**REVERCHON, S.A. INDUSTRIES, FRANCE
"HIMALAYA"
April 22, 1998**

Subject : Repair of « HIMALAYA » amusement ride

Technical aspects corrective action plan

Use of Lap Bar Latch Tolerance Gauge for Reverchon HIMALAYA

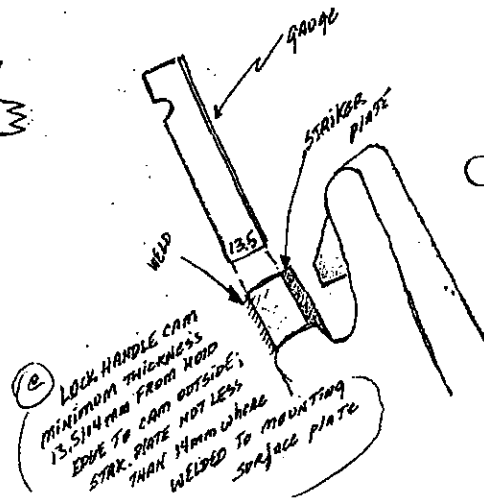
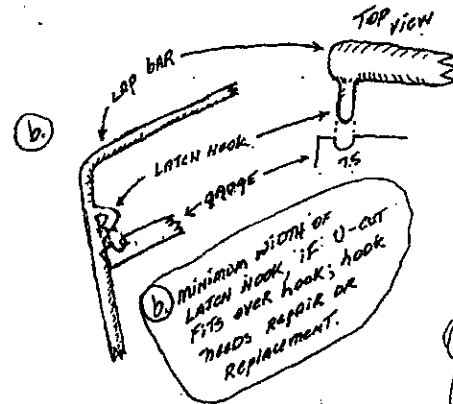
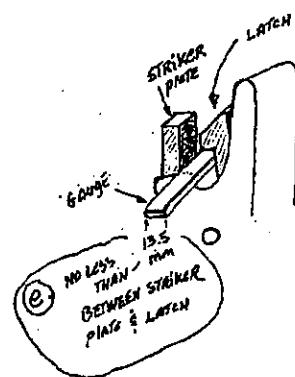
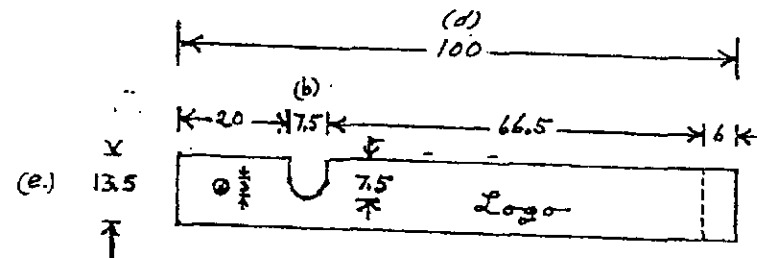
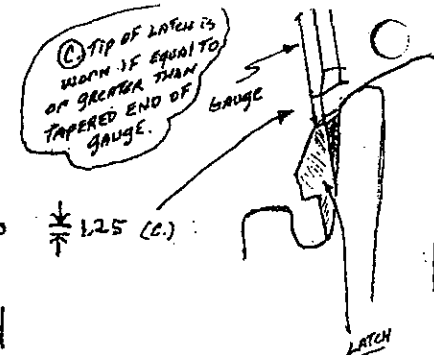
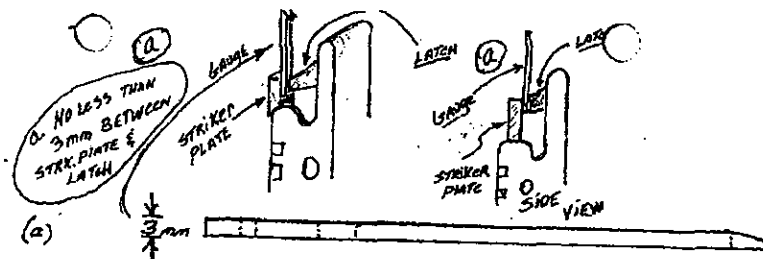
- (a) Thickness - 3 mm Length between latch and striker plate, if length is less than 3 mm, latch needs repair or replacement.
- (b) U-cut - 7,5 mm Minimum width of latch hook; if U-cut slides over hook, the hook will need repair or replacement (latch hook thickness latch hook - original thickness 10 mm)
- (c) Tapered End - 1.25 mm Tip is worn if latch tip is equal to or greater than tapered end thickness.
- (d) Length - 100 mm Straight-edge for flatness measure
- (e) Width - 13,5 mm Lock handle cam minimum thickness measure 13.5/14 mm from hold edge to cam outside; striker plate not less than 14 mm where welded to mounting surface plate.

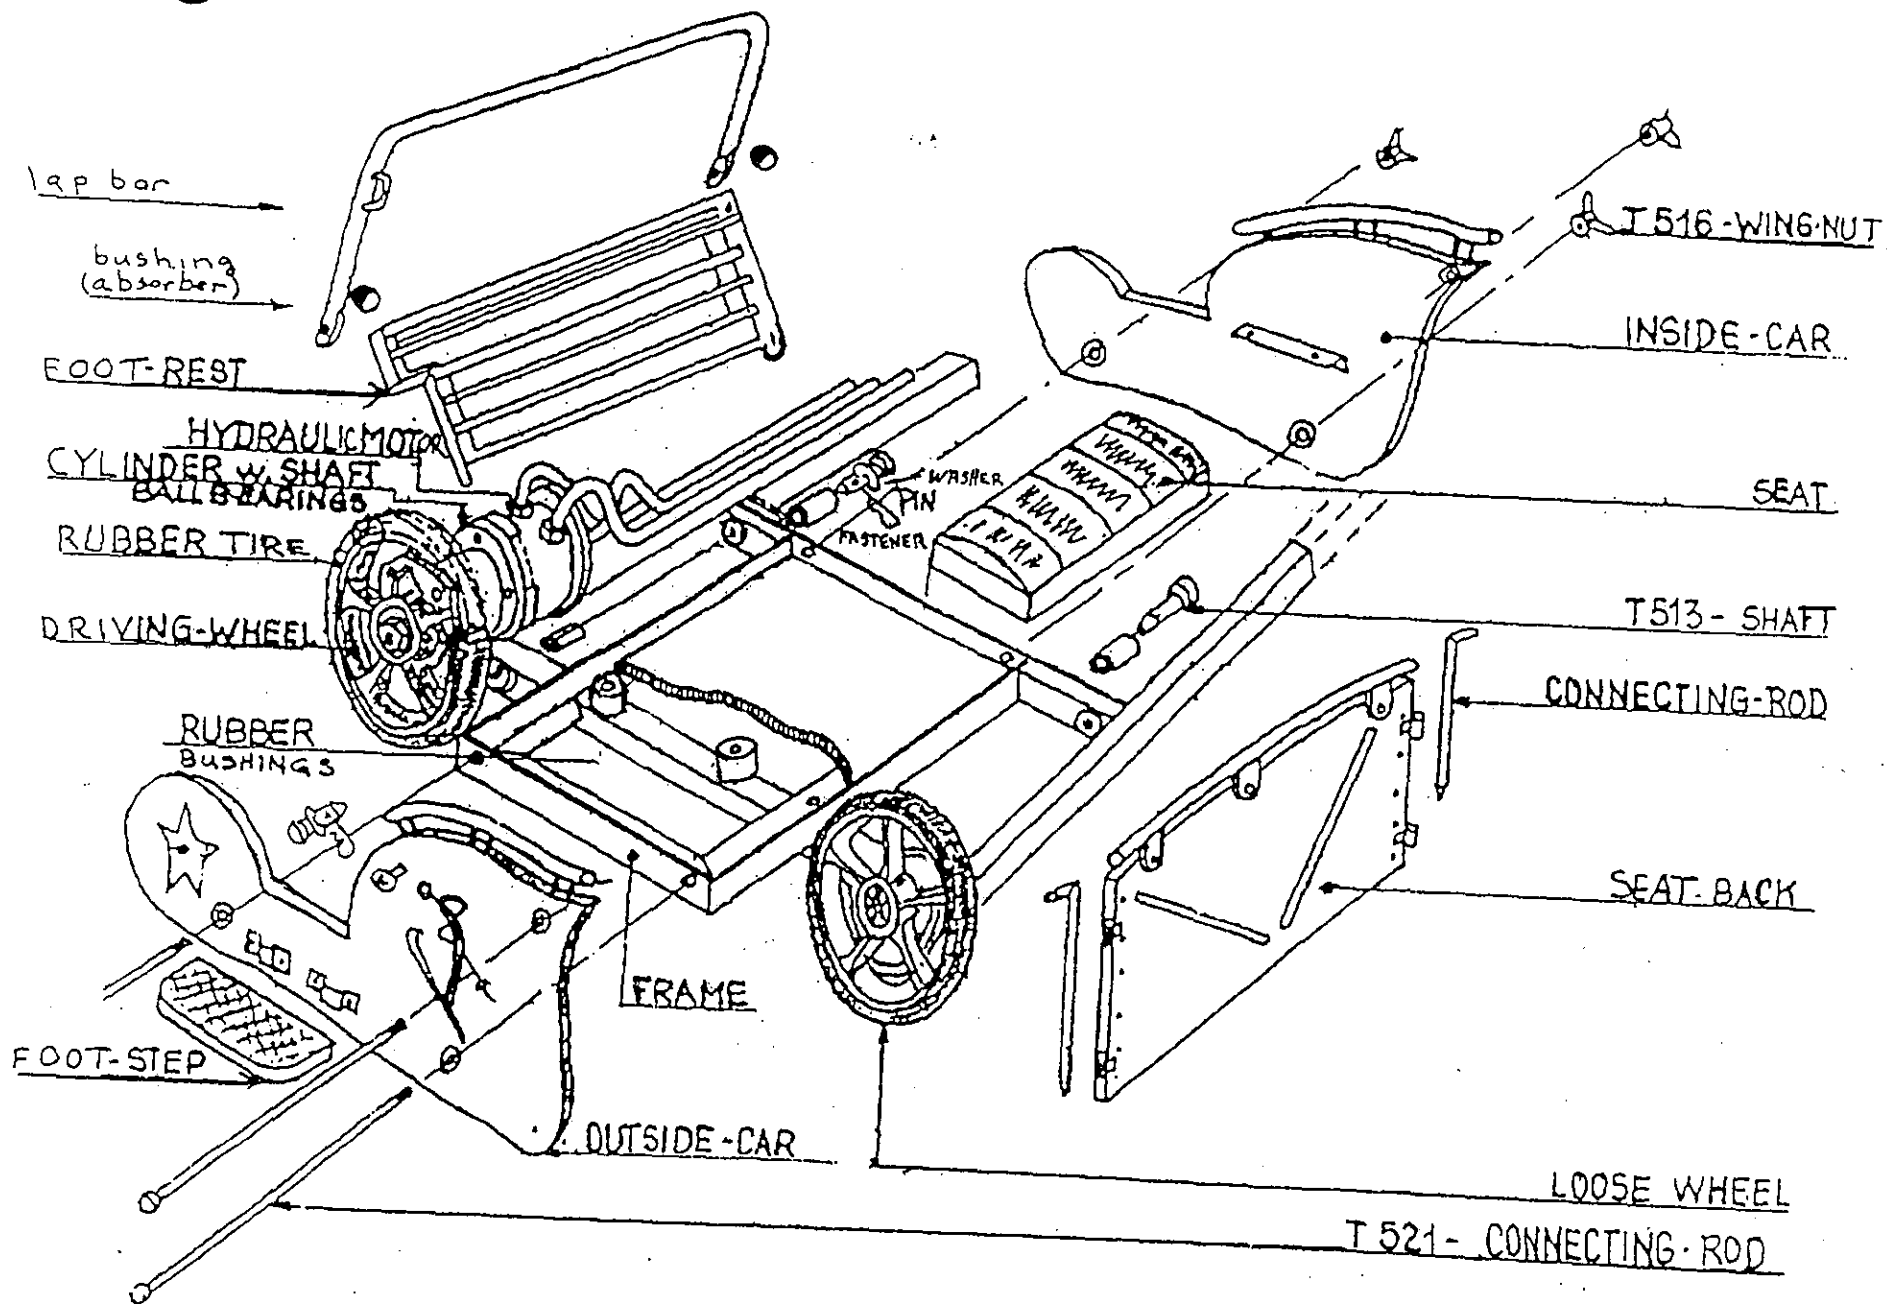
1. **Stainless steel cotter pins** or R-keys, with hardened washers (with a hole diameter that closely fits the car's lower lap bar pin) are to be used as fasteners for car lap bars. These stainless steel fasteners are non-magnetic and can be checked with a magnet. The stronger stainless steel cotter pins have been used on amusement rides where there is a concern of removal by a patron. A 304, 316 or 18-8 stainless steel alloy cotter pin could be more difficult to dislodge than a wired R-Key. Alternately, "rue" pins and "circular cotter pins" are also appropriate fasteners. A hardened washer that closely fits the lower lap bar pin that is placed between the stronger fasteners and lower lap bar should reduce fastener shearing. The lower lap bar fasteners require inspection, maintenance, and replacement as necessary. [SEE ATTACHED DRAWING]

8. Inspect rubber bushings (absorbers), both on the lap bar latching system and under each car; for bulging, cracking, wear, and deterioration that affects the bushings purpose and effectiveness. **Replace bushing if indicated. [SEE ATTACHED DRAWING]**

GOUPILLE CYLINDRIQUE FENDUE

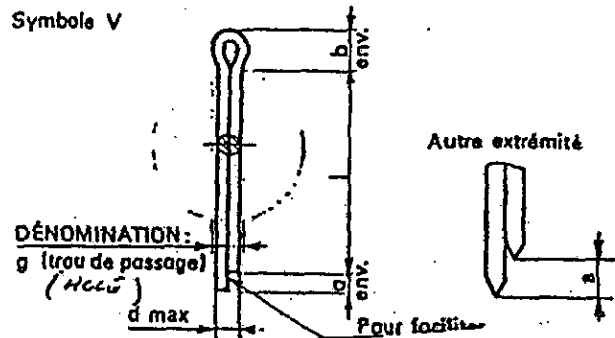
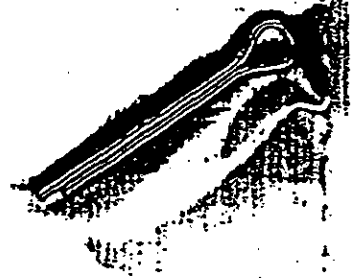
WASHER M16

Split R-Key 4-32

Speed control device

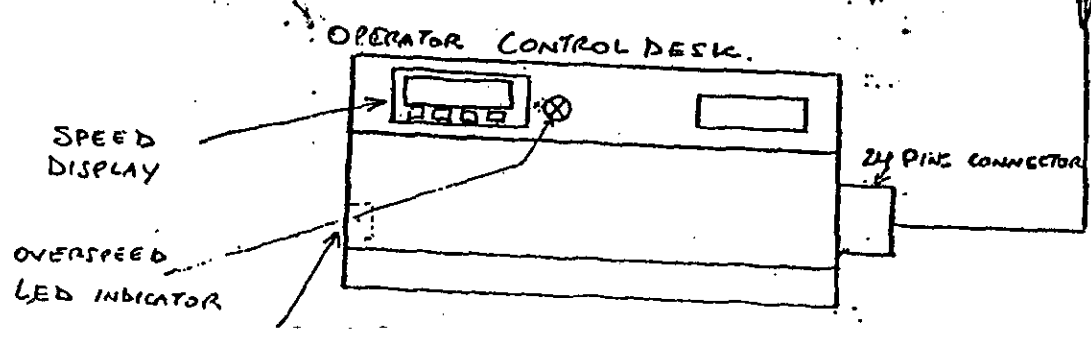
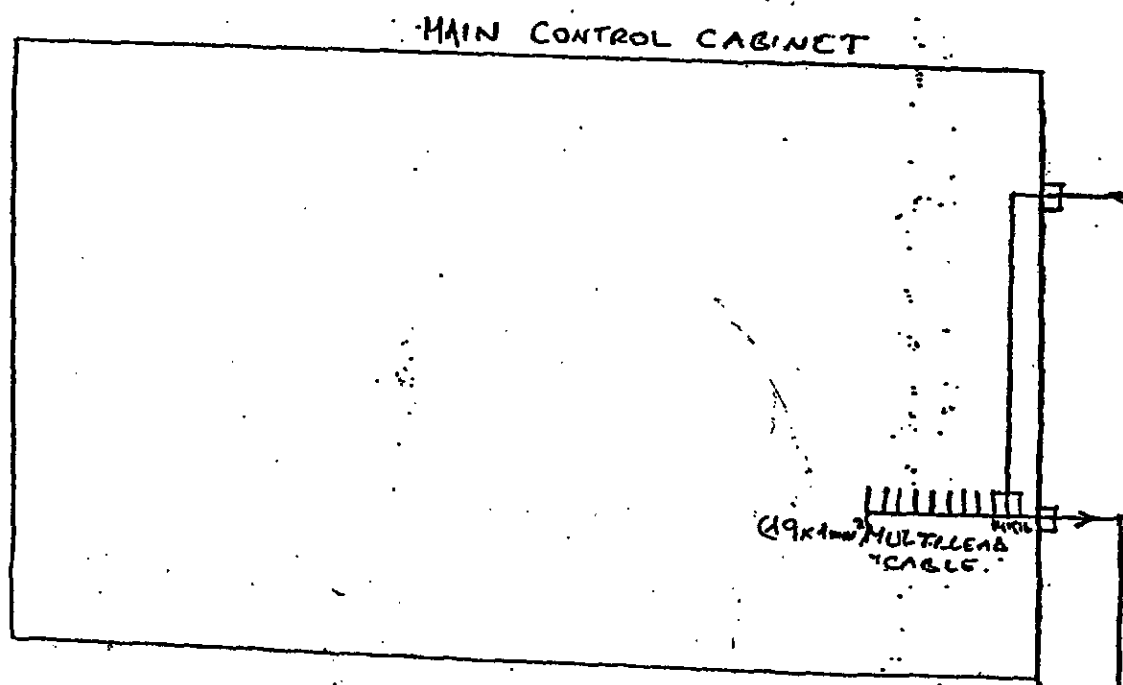
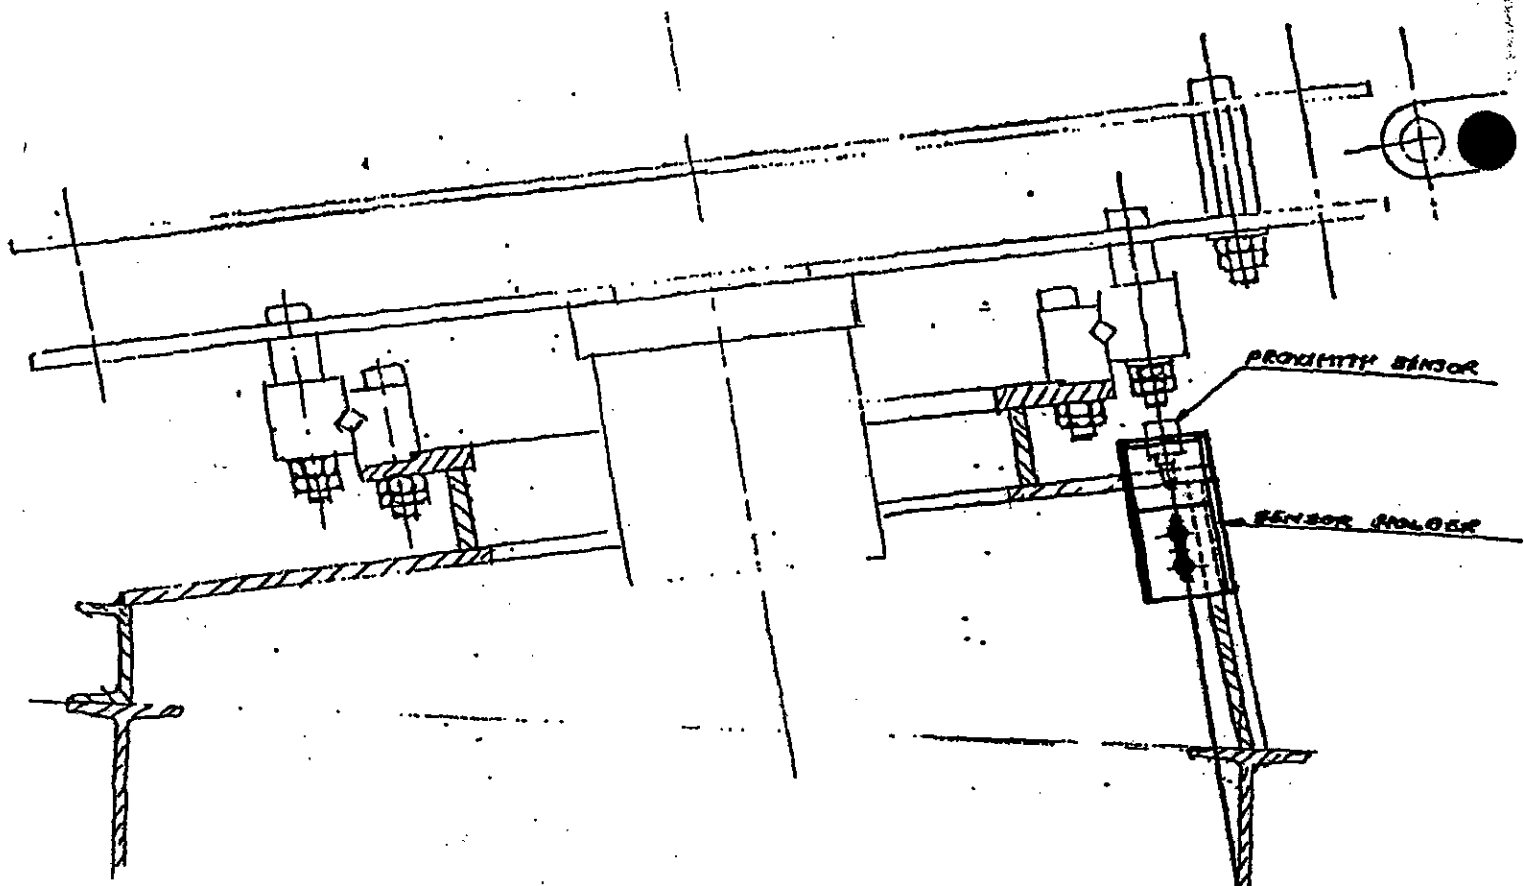
Regarding the speed control device, we propose you to find hereafter 2 detailed main drawings of the installation of a sensor to determine the frequency of the ride.

This sensor indicates the speed directly in RPM.

If the speed goes over the threshold corresponding to the maximum speed, a warning blister lights up and a buzzer sounds a warning in the station the if the ride rotates faster than its permitted speed.

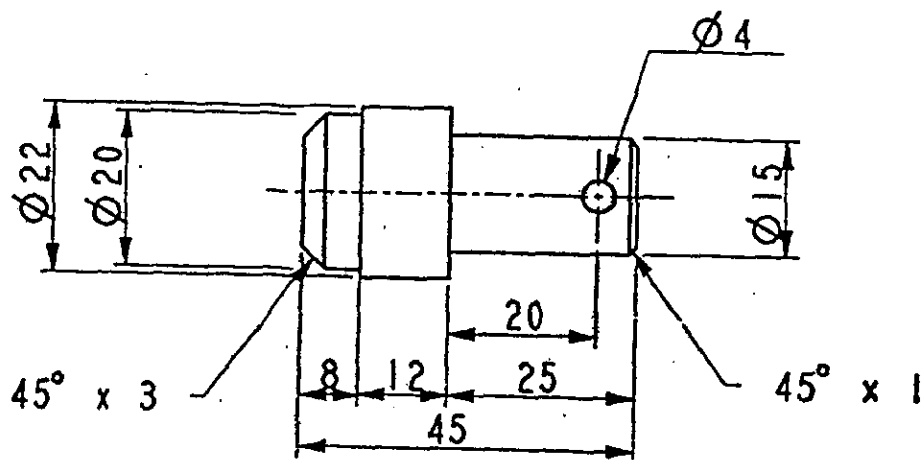
To replace the 2 inferior axles maintaining the bar (see photo hereafter) by one axle which is designed on drawing number 40-6191-42 A- Insert.

Need to replace

Please note that, for the moment the best solution a split-R-key with a washer is, provided that they are changed at each dismantling of the ride and a new one is used every next erection.

Use of Lap Bar Latch Tolerance Gauge for Reverchon HIMALAYA

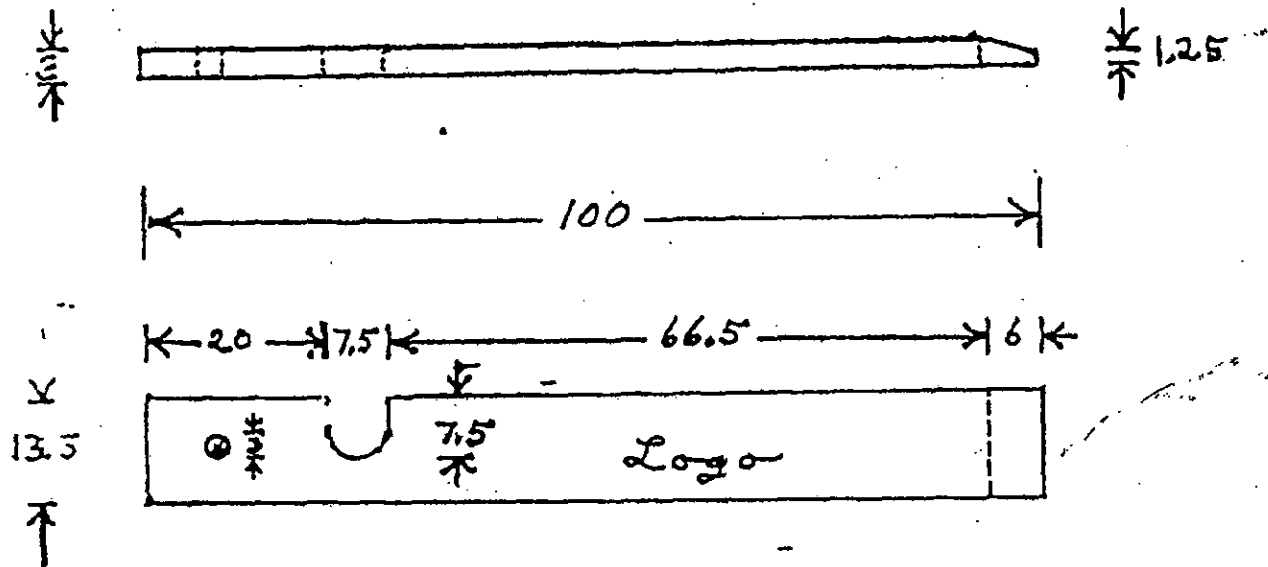
- (a) Thickness - 3 mm Length between latch and striker plate, if length is less than 3 mm, latch needs repair or replacement.
- (b) U-cut - 7,5 mm Minimum width of latch hook; if U-cut slides over hook, the hook will need repair or replacement (latch hook thickness latch hook - original thickness 10 mm)
- (c) Tapered End - 1.25 mm Tip is worn if latch tip is equal to or greater than tapered end thickness.
- (d) Length - 100 mm Straight-edge for flatness measure
- (e) Width - 13,5 mm Lock handle cam minimum thickness measure 13.5/14 mm from hold edge to cam outside; striker plate not less than 14 mm where welded to mounting surface plate.
